City of Surrey PLANNING & DEVELOPMENT REPORT File: 7914-0231-00

Planning Report Date: December 15, 2014

in order to permit the development of Phase 2 of a mixed-use development, consisting of 2 residential towers (39-storey and 12-storey) and 13-storey office building with lower level commercial uses.

LOCATION: 9808 - King George Blvd

sheet A206

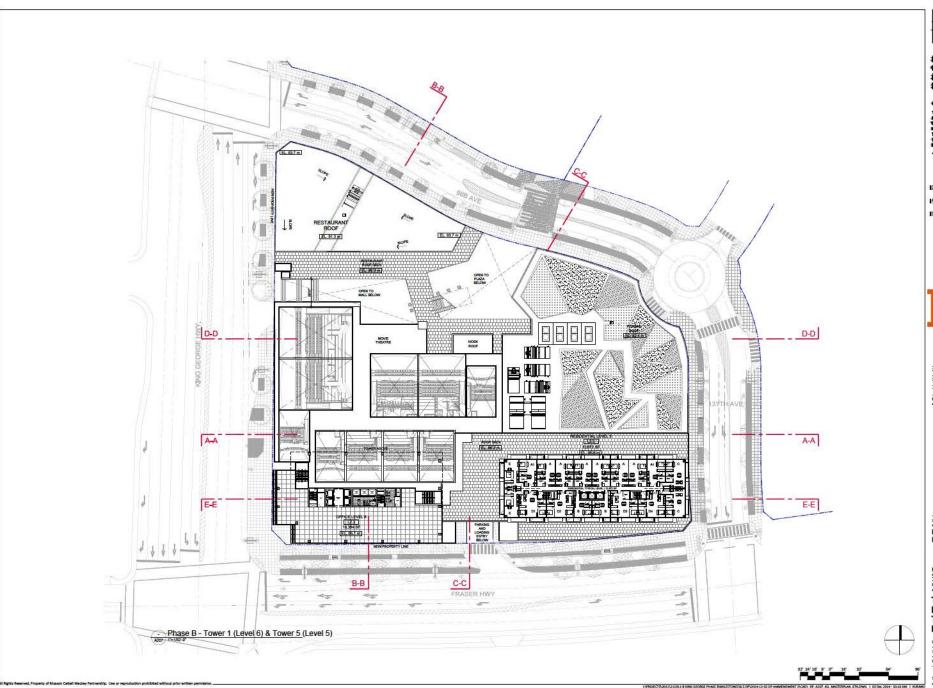
• There is a lot of variety in the commercial/retail podium however it seems to work as it is carefully articulated. There is generosity with the materials chosen and a rhythm that is pleasing to the street. Attention should be given to how the storefronts are varied (consider varied setbacks, widths, how doors open to create relationship between indoor and outdoor space, etc.). Bike racks should be added, as well as contemporary furniture, to create a truly social space.

Daycare outdoor space is planned at the second floor. Please see Drawing A206.
